# UNITED STATES PATENT AND TRADEMARK OFFICE

APPLICATION NO.	FILING DATE	FIRST NAMED INVENTOR	ATTORNEY DOCKET NO.	CONFIRMATION NO.
10/091,502	03/07/2002	Yong Che	220305US0	8897
22850	7590	02/17/2004		
OBLON, SPIVAK, MCCLELLAND, MAIER & NEUSTADT, P.C. 1940 DUKE STREET ALEXANDRIA, VA 22314			EXAMINER ALEJANDRO, RAYMOND	
			ART UNIT	PAPER NUMBER
			1745

**Advisory Action**

10/091,502

**FIG. 1**

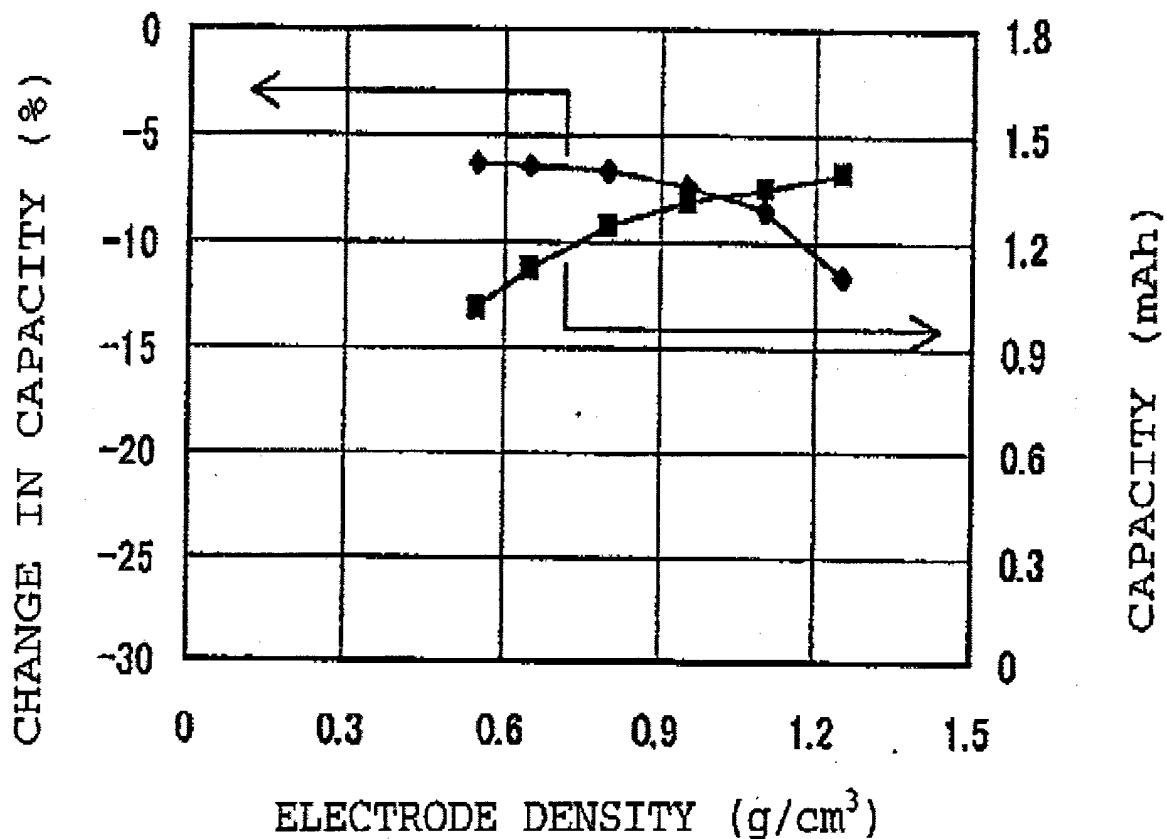
Furthermore, the objective evidence of nonobviousness is not commensurate in scope with the instant claims which the evidence is offered to support. For instance, it is noted that data of Figure 1 showing improved capacity and cycle reduction characteristics does not evidence unexpected results for the entire claimed range of 0.6-1.2 g/cc or 0.7-1.0 g/cc because as apparent from **Figure 1** below, significant initial capacity of more than 1.2 mAh is reached at negative electrode densities greater than about 0.8-0.85 g/cc (not 0.6 g/cc or 0.7 g/cc as instantly claimed) and significant reduction in capacity of more than 7 % (assuming that 7 % is an acceptable reduction) are observed at negative electrode densities as low as about 0.9 – 0.95

*g/cc or higher (not 1.0 g/cc or 1.2 g/cc as instantly claimed). For that reason, it is contended that the objective evidence of nonobviousness is not commensurate in scope with the present claims.*
